## ***Interactive comment on “Global root zone storage capacity from satellite-based evaporation” by L. Wang-Erlundsson et al.***

**L. Wang-Erlundsson et al.**

Received and published: 30 March 2016

**Fig. 1.** The mean RMSE improvement in simulated monthly E (2003–2013) by implementing  $S_{\text{R},\text{CRU-SM,Lyrs}}$  instead of  $S_{\text{R},\text{STEAM}}$  in STEAM. The number of represented grid cells are in parenthesis.

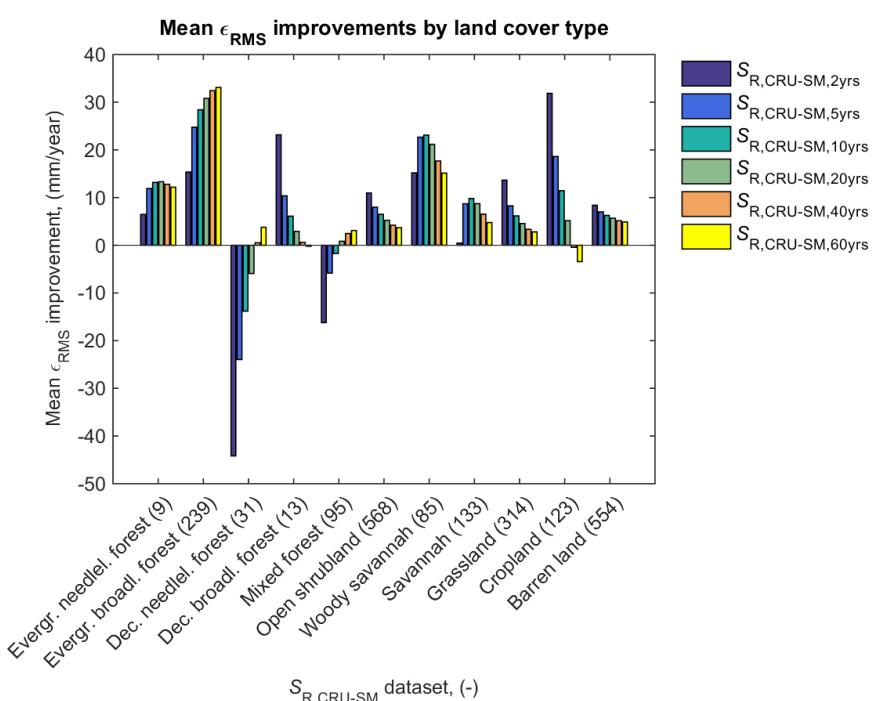
**Page 21, line 14 f: The term "speculate" is not nice in a paper. Is there any reference for the message "deciduous forests need a large root zone storage capacity to cater for dry periods during their most active summer months" available or is it something you found out during your research? Please try to verify this. Same for the next sentence.**

The coping mechanism of deciduous forest is to shed leaves when there is too much moisture stress. In semi-arid tropical climates we can see this happen when the wet

season comes to an early end; likewise we see this in temperate climates when the cold season starts early. However, shedding the leaves during the wet season (semi-arid tropics) or the growing season (summer in temperate climates) is not attractive because it prevents reproduction. So the only option to prevent lack of reproduction is to create adequate storage. This storage needs to be big enough so as to reach reproductive age.

Therefore, it also depends on the age of the species. An annual species only needs to cater for an average year (or somewhat drier than average year), particularly if there is a seed stock that can survive drought, or if the plant can go dormant (grasses). So age also comes into the equation. In the analysis, the “deciduous forest” constitute of both “deciduous needleleaf forest (DNF)” and “deciduous broadleaf forest (DBF)”. We lumped the needleleaf and broadleaf to prevent statistical artefact due to a low number of grid cells covered (i.e., only 13 grid cells of deciduous broadleaf forest and 31 grid cells of DNF, see figure below). However, this concealed an effect that probably is real – i.e., that DNF performs the best with a very long return period, whereas DBF performs the best with a shorter return period.

It appears that the age structure between DNF and DBF are radically different. Global mapping of forest age structure using country database and MODIS data (Poulter, 2012) show that DNF have a very high age, whereas large areas of DBF are notoriously young. The majority of the forests were > 80 years in the region (i.e. Siberia) with highest concentration of DNF (i.e., where our analysis covered due to the 90 % single land use occupancy requirement). By contrast, 1-30 years and 31-80 years were far more common in the regions with high DBF concentrations (i.e., in Easter U.S. and South America). Based on U.S. forest inventories, (Hicke et al., 2007) report mean forest age of 60-100 years, with hardwood (incl. DBF) younger than softwood (incl. DNF). In terms of longevity, it also seems that gymnosperms (incl. DNF) beat the angiosperms (incl. DBF). The mean maximum age of 60 species of reported North American angiospermous trees is 248 years, whereas it is 596 years for the 50 species

of gymnospermous trees (Larson, 2001; Loehle, 1988). Longevity could be explained by strong defence mechanisms against fungi and insects, lack of physical environmental damage, but also low occurrence of environmental stress such as drought (Larson, 2001). Thus, we think it could be correct that deciduous needleleaf forests, which is older, also have root zone storage capacities that have catered for longer drought return periods.

In the revised manuscript, we will discard the lumping of needleleaf and broadleaf, and instead report all forest types separately together with grid cell numbers. We will delete the wording “speculate” and the possible explanation of poor snow simulation in STEAM. Instead, we will explain the result by relating it to studies of forest age.

(We changed the soil moisture stress function in STEAM, see response to referee #1’s specific comments and Axel Kleidon. This changed the best return period for mixed forest, woody savannah, savannah and evergreen broadleaf forest, but does not affect the deciduous forests and the discussion above.)
